Form C-103
Revised August 1, 2011

SUNDRY NOTICES AND REPORTS ON WELLS (DO NOT USE THIS FORM FOR PROPOSALS TO DRILL OR TO DEEPEN OR PLUG BACK TO A DIFFERENT RESERVOIR. USE "APPLICATION FOR PERMIT" (FORM C-101) FOR SUCH PROPOSALS.)	
1. Type of Well: Oil Well <input checked="" type="checkbox"/> Gas Well <input type="checkbox"/> Other <input type="checkbox"/>	
2. Name of Operator Vanguard Operating, LLC	
3. Address of Operator 5847 San Felipe St. Ste. 3000, Houston, TX 77057	
4. Well Location Unit Letter <u>O</u> : <u>1/4</u> feet from the <u>SW</u> line and <u>1/4</u> feet from the <u>SE</u> line Section <u>17</u> Township <u>20S</u> Range <u>30E</u> NMPM County <u>Eddy</u>	
11. Elevation (Show whether DR, RKB, RT, GR, etc.)

STATE A1 No. 001
330' FNL & 1980' FEL
UT O, SW1/4, SE 1/4, SEC 17, T 20S, R 30E
EDDY COUNTY, NM
30-015-04685
BARBER (YATES)
B-2386-2

CONDITIONS FOR PLUGGING AND ABANDONMENT

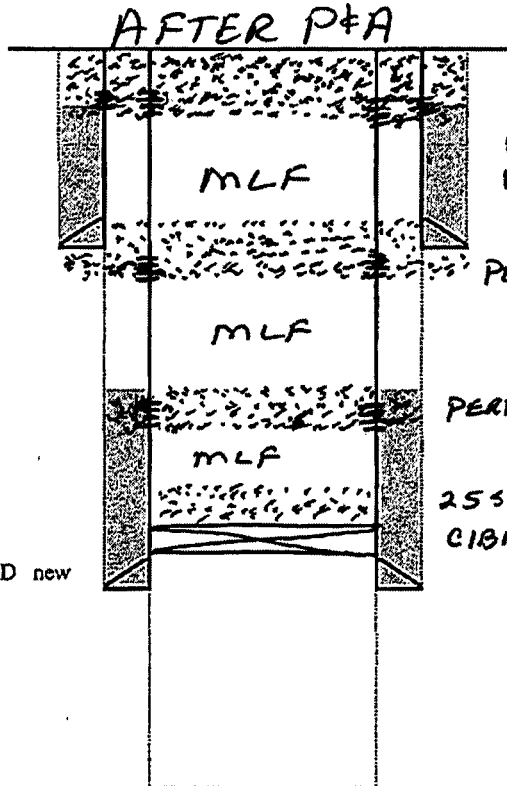
> Perf not needed. Salt Section to be covered 420' - 1085' (cmt 1135' - 380')
